Certified Action of the City of Raleigh Planning Commission

Case File / Name: SP-35-10 / Nationwide Mutual Parking Lot Expansion

SUBJECT: SP-35-10 / Nationwide Mutual Parking Lot Expansion

Staff Report

SP-35-10 – Site Plan

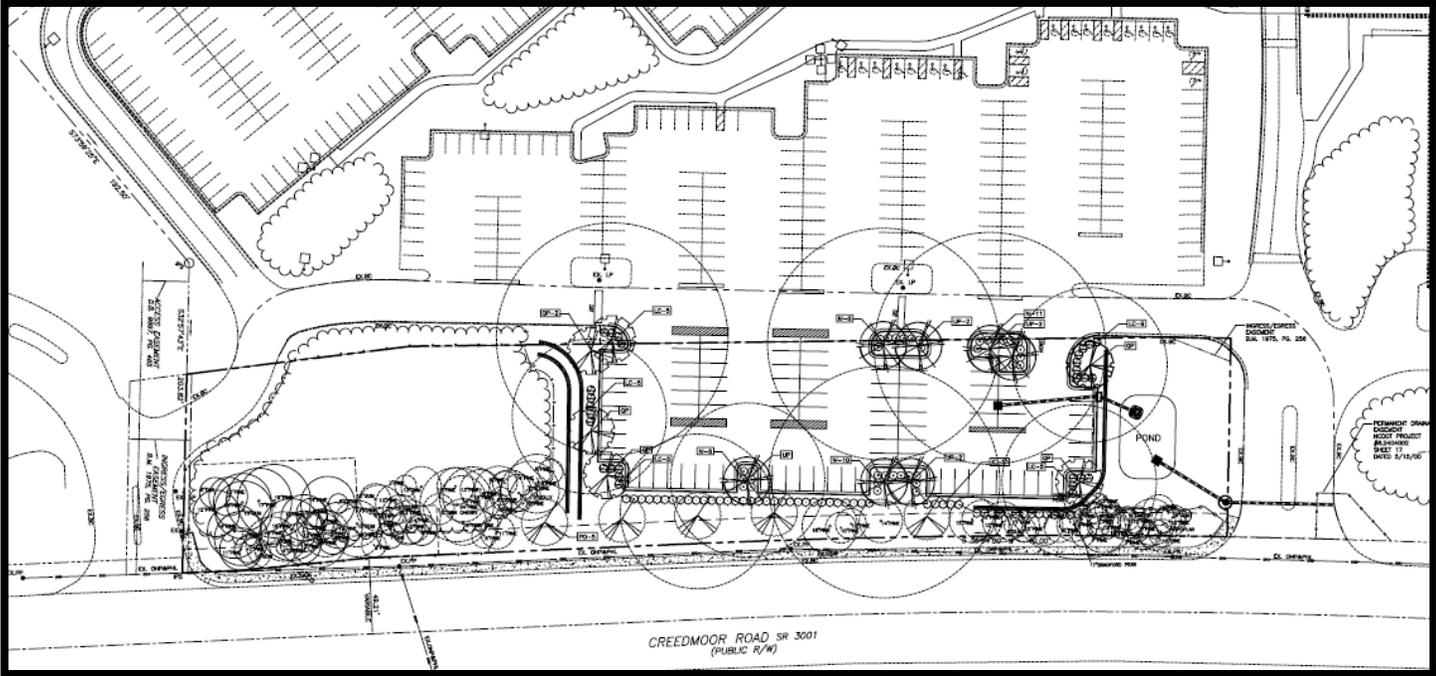
**ADDITIONAL
NOTES:** Plan was deferred at the October 26, 2010 Planning Commission meeting to address pedestrian connectivity of code section 10-2091 and Comprehensive Plan policy LU 4.5. The plans were revised to show additional sidewalk construction linking the primary building to the street as well as reconfiguring the existing parking spaces and striping to provide pedestrian walkways from the proposed parking lot expansion.

- (1) That two, striped crosswalks are painted throughout the existing parking lot as shown on the preliminary plan to facilitate pedestrian movement from the parking areas to the building entrance. To prevent cars from encroaching on the crosswalks, wheel stops will be installed in the parking spaces;

- (2) That the sidewalk from the Nationwide Mutual Insurance Building be constructed as shown on the preliminary plan to provide access to Creedmoor Road, with the inclusion of handicapped ramps;

- (3) That a 10x20 foot transit easement located on Creedmoor Road be approved by the Transit Planner in the Public Works Transportation Department, as shown on the approved preliminary plan, be shown on all maps for recording, and that a transit easement approved by the City Attorney is recorded with the local County Register of Deeds. That the recorded copy of this transit easement be provided to the Planning Department within 14 days of authorization of lot recording. If a recorded copy of this easement is not provided to the Planning Department within the 14 day period, further plat recordings and building permits authorization may be withheld;

APPEARANCE COMMISSION: The Appearance Commission has made the following comments on this preliminary plan. Shown below are comments and applicant responses:

Comment	Response
1. The committee recommends that additional effort be made to mitigate visual impacts of locating the parking area adjacent to Creedmoor Road, including but not limited to: <ul style="list-style-type: none"> • Adding sufficient understory shrubs and trees to the proposed streetyard plantings to screen the lot fully from view [commensurate with code Sec. 10-2132.2(d)(2),(3),(4)& (6)]. • Landscaping the stormwater 	<ul style="list-style-type: none"> • Dwarf Buford Hollies were planted in the streetyard • Northern bayberry were planted along the stormwater pond

BMP, including continuing the proposed line of streetyard tree plantings into the site along the existing access drive [commensurate with code Sec. 10-2132.2(d)(2)&(3)].

2. Improve pedestrian connectivity by striping all crosswalks [commensurate with code Sec. 10-2132.2(d)(1)].
 - Crosswalks are striped
